PRODUCT ADVISORY

Data Sheet Specification Change for Intersil Products ISL59601*, ISL59602*, ISL59603*, ISL59604*, and ISL59605*

Refer to: PA12072

Date: September 6, 2012

• Figure 45 – Application Circuit for UTP Cable (Page 20):

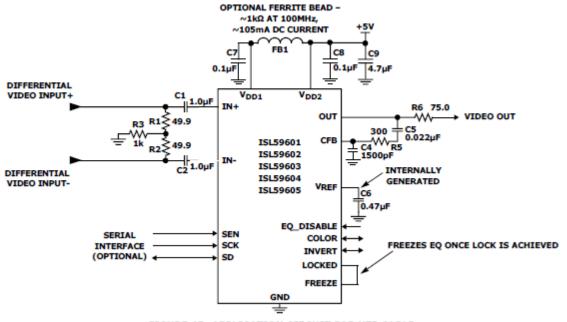
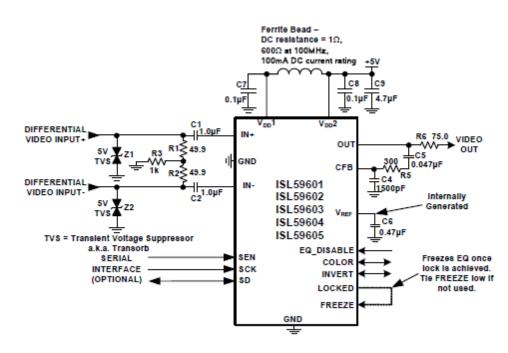
This advisory is to inform you that Intersil has made an enhancement to the data sheet application circuits for the listed ISL59601*, ISL59602*, ISL59603*, ISL59604*, and ISL59605* products. Although the current application circuitry is functionally correct, the update will improve Intersil's product performance. The changes affect the termination requirements outlined in the *Figure* 45 – *Application Circuit for UTP Cable, Figure* 46 – *Application Circuit for COAX Cable, Figure* 47 – *Application Circuit for UTP/COAX Cable,* and verbiage in the related sections. Details regarding the changes to the figures are contained on the following pages. The updated data sheet is available on the Intersil web site at http://www.intersil.com/content/dam/Intersil/documents/fn67/fn6739.pdf.

Change From:

Change To:

• Figure 46 – Application Circuit for COAX Cable (Page 21):

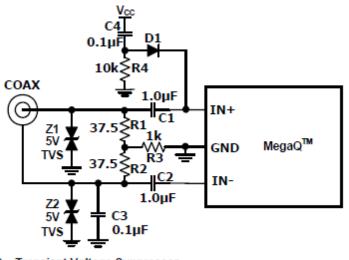
Change From:

Change To:

TVS = Transient Voltage Suppressor a.k.a. Transorb
